**MAC-45B KMM901 ABC  
 CONTROLLER REPLACING  
 WITH OMRON CJ2M-CPU13  
 PLC**

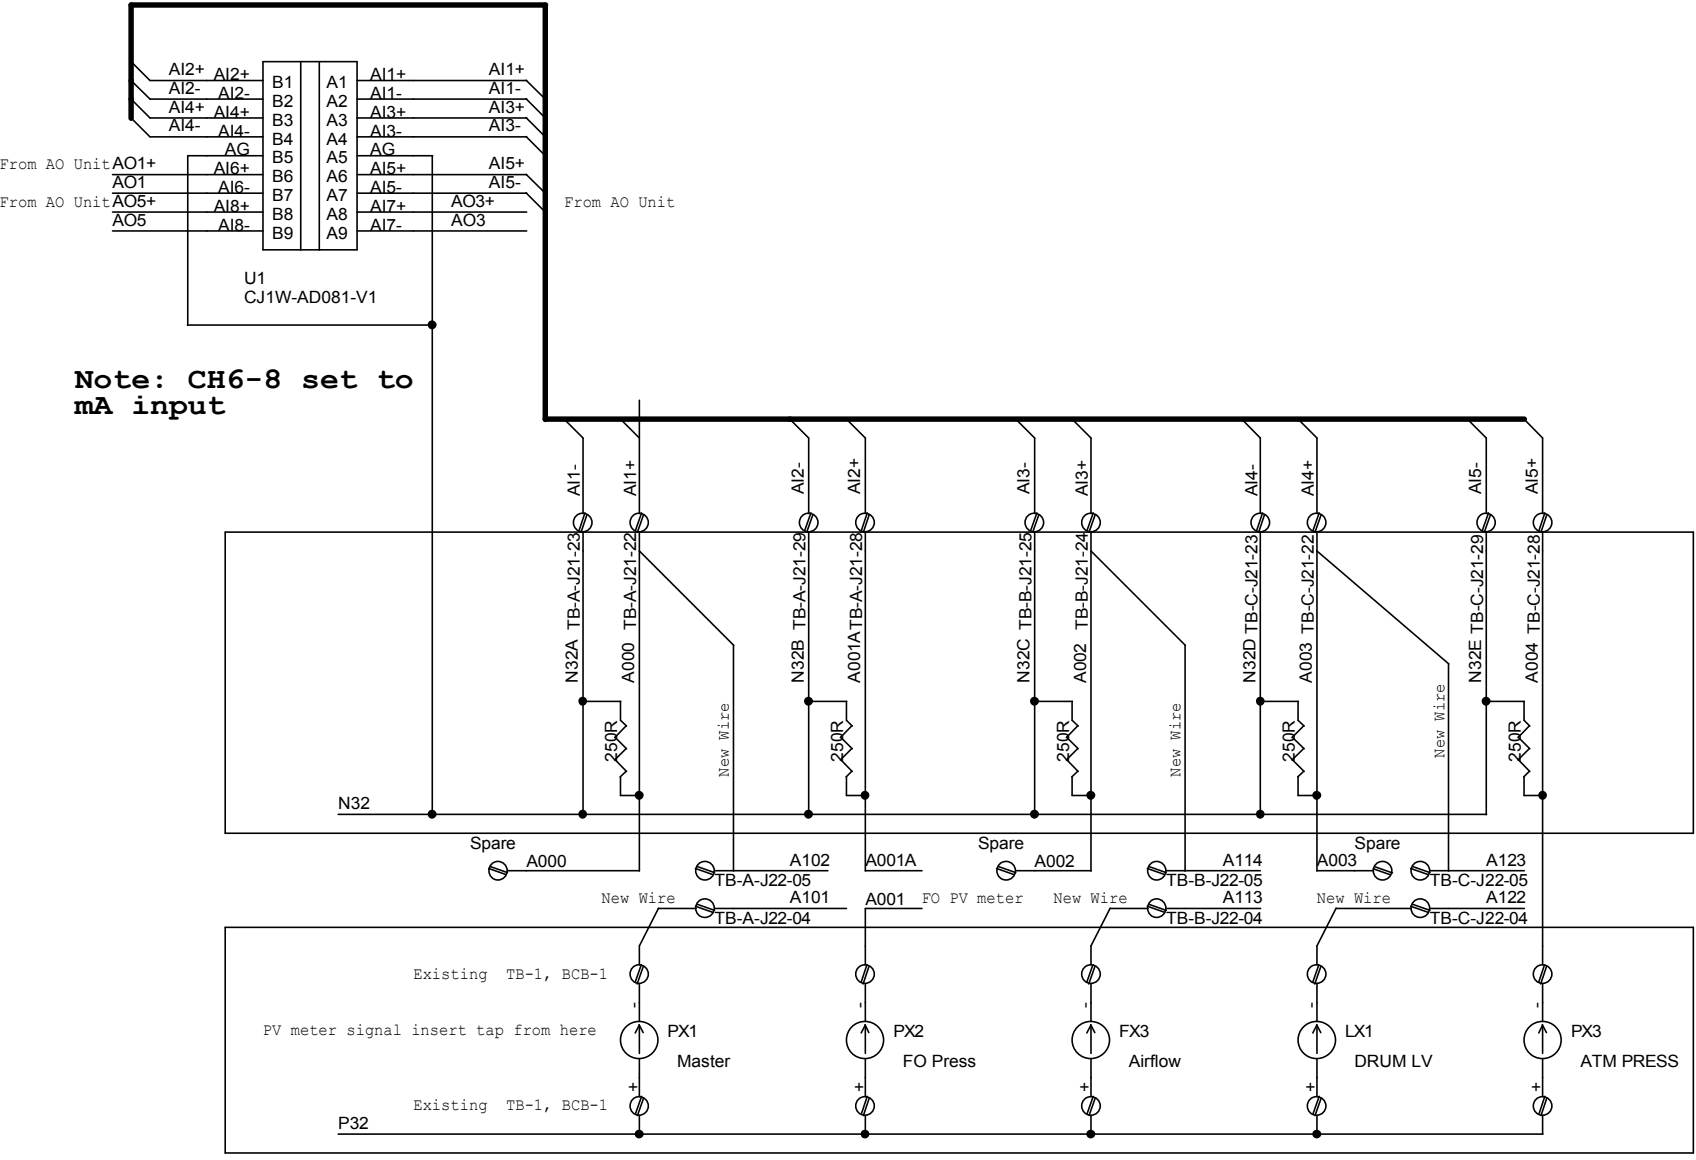
**Note: CH6-8 set to mA input**

1. Disconnect A000 from TB1 and put to spare terminal TBA-34
2. Use extra wire link A000 cable wire (without A000 label) to TBA A101 let mA pass MST PV meter
3. Link A102 (MST PV meter return) to TBA A000
4. For Air Tx and Level Tx do it in same way
